SI B64 06 13
Body Equipment

This Service Information bulletin supersedes SI B64 06 13 **dated November 2013**.

A/C Cooling: Intermittent Reduction of Air Flow

F30

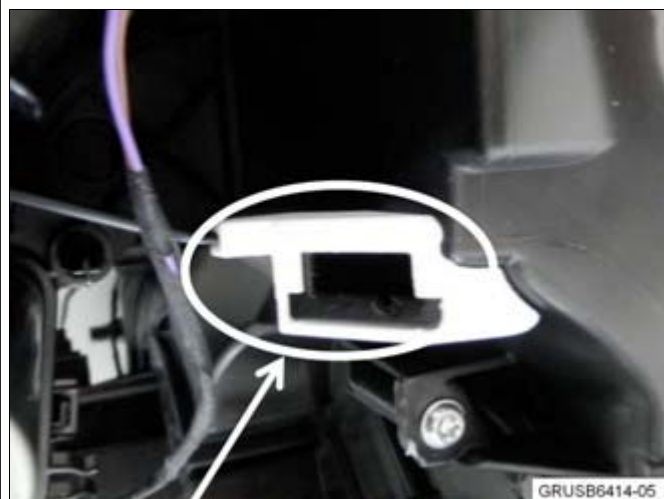
1. Refer to Repair Instruction 51 45 195 and remove the passenger side footwell cover trim.

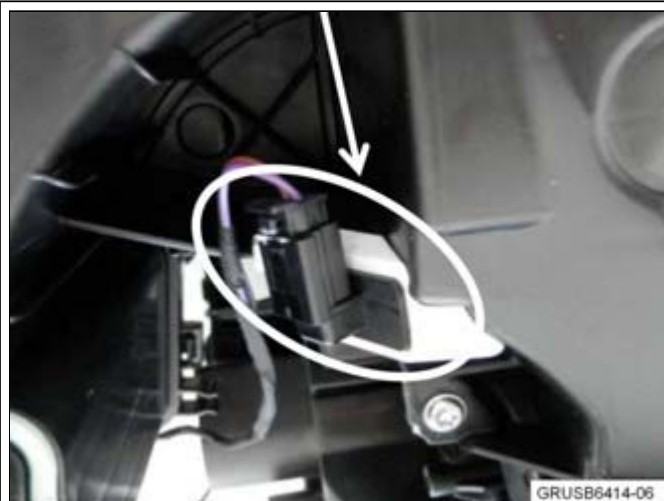
2. With the footwell panel removed, locate the evaporator temperature sensor opening (sensor removed for clarity). Note the gap between the sensor opening and the evaporator case. If the sensor opening contact surface is slightly angled as shown, this housing is **NOT** affected by this repair procedure. In this

case, proceed with normal A/C diagnostic procedures.
	3. If no gap exists and the sensor opening contact surface is not angled as shown, the IHKA housing must be modified. Do not replace any parts. The repair procedure includes installing a new adapter to correct the gap of the sensor as shown in the next steps.
	4. Also, if a yellow-colored marking exists on the sensor connection, the new adapter must be installed. Refer to Repair Instruction 64 11 943 and remove the evaporator temperature sensor.
	5. Insert the new adapter firmly into the sensor opening, as

shown.

6. Insert the sensor through the opening in the adapter, and then install all removed parts in the reverse order of their removal.
